**WRITTEN REPRESENTATION
ON BEHALF OF McDONALD'S RESTAURANTS LIMITED
PROPOSED HIGHWAY WORKS A38, DERBY**

ADL/RG/2680/05D

November 2019

Document: Written Representation
Project: Proposed Highway Works A38, Derby
Client: McDonald's Restaurants Ltd
ADL Reference: 2680

APPENDIX 6.2

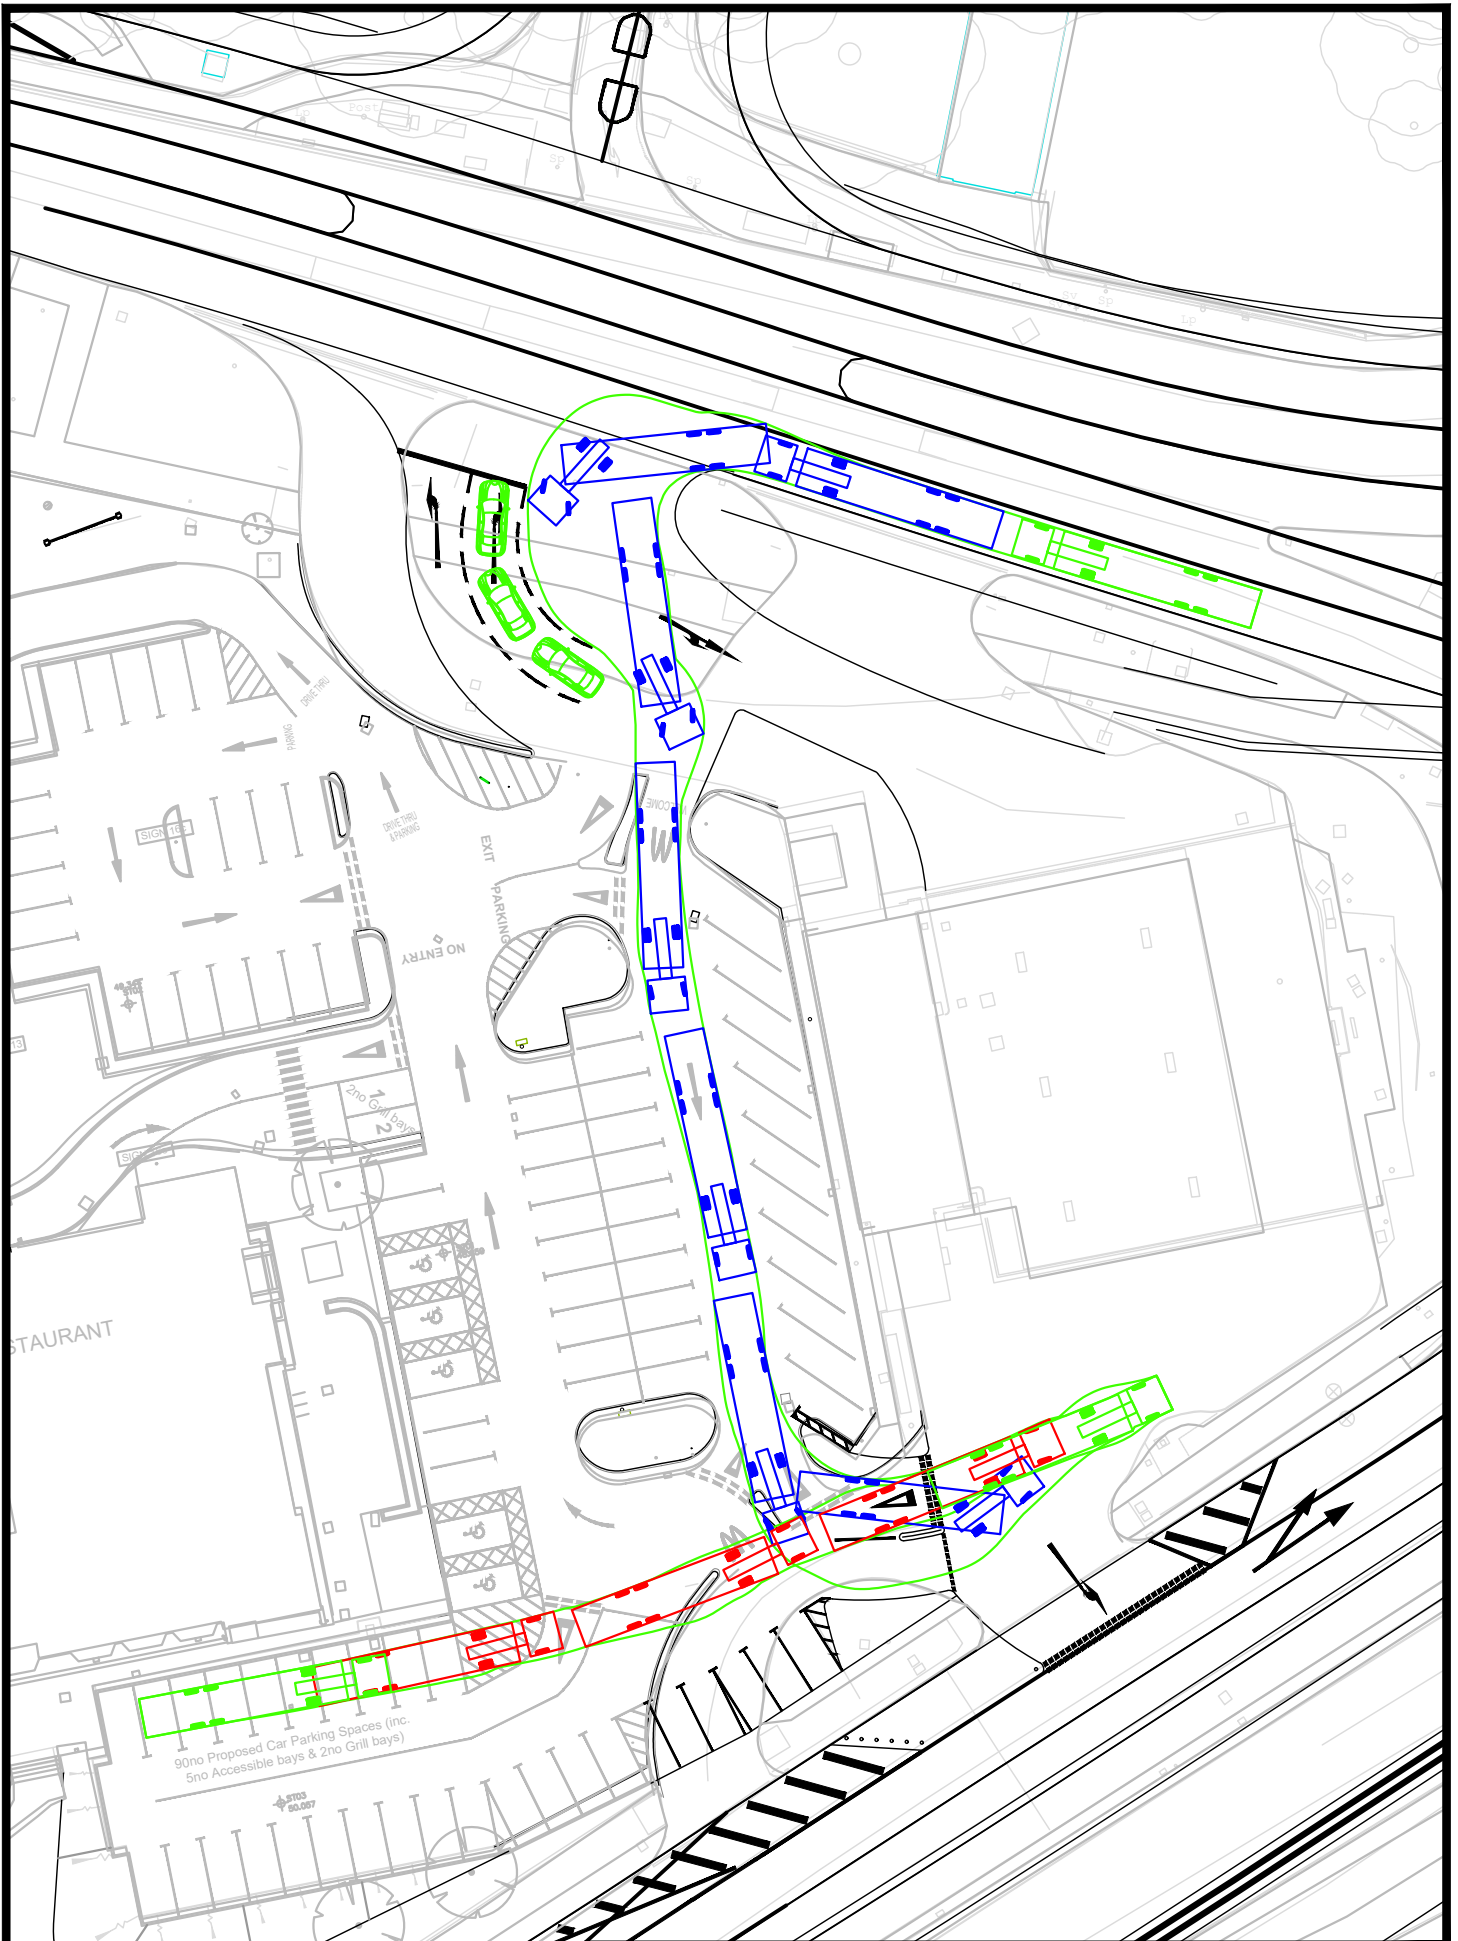
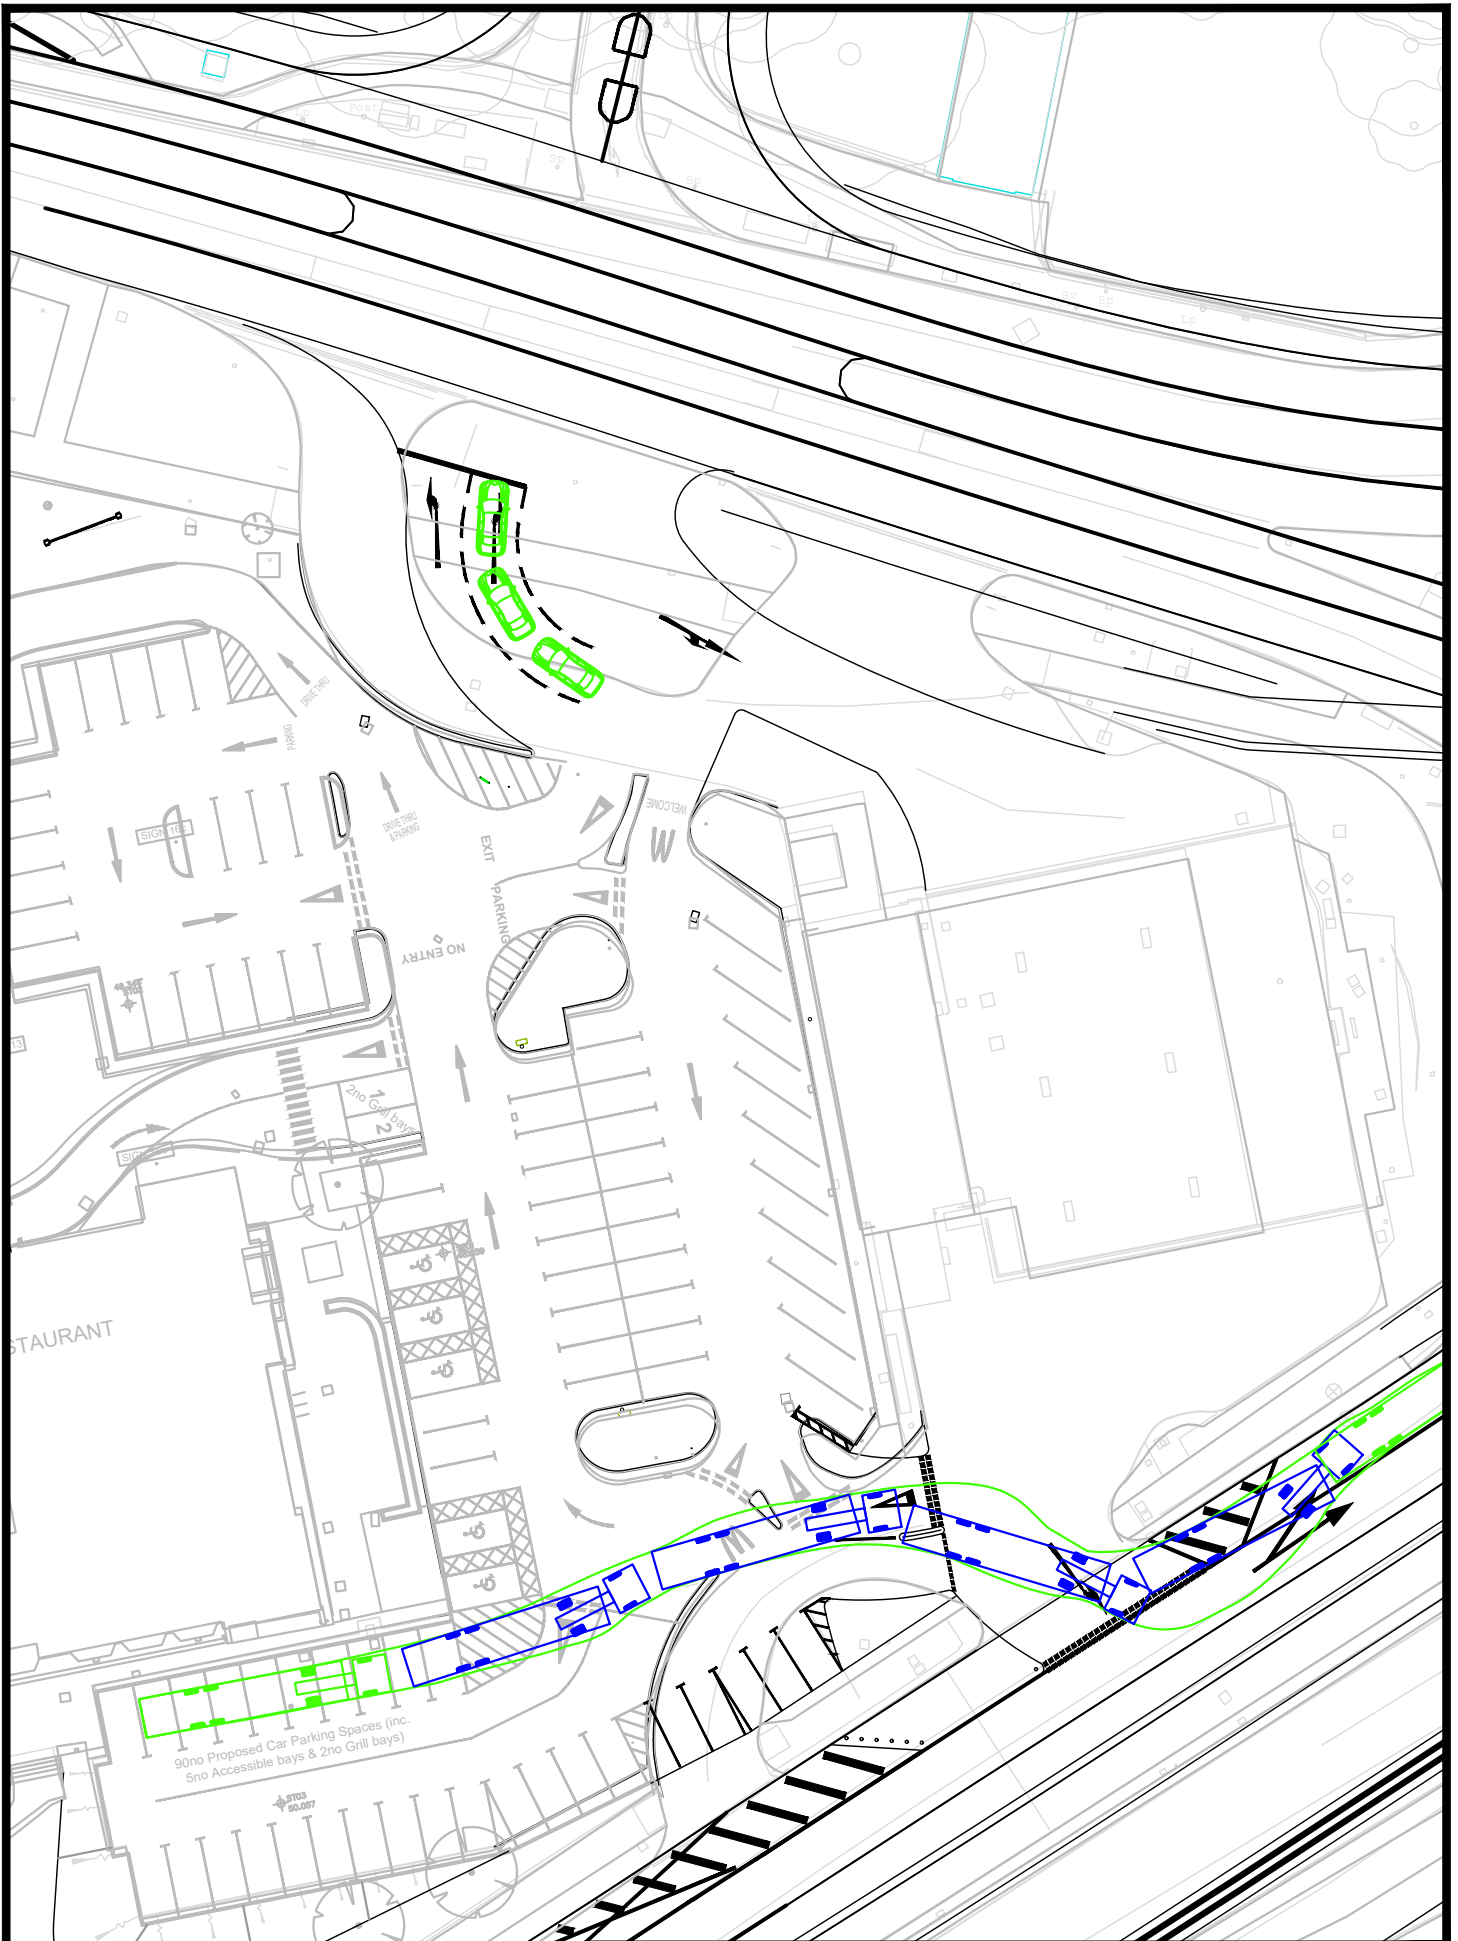
- 4.1.5 The proposed junction geometry for the proposed A52 signals would require a very tight manoeuvre from the HGV to successfully turn into the site. Swept paths are provided at Appendix 6.0 and show the difficulty the driver would experience and also shows the elements of the existing McDonald's layout which would need to be overrun to accommodate the updated delivery route.
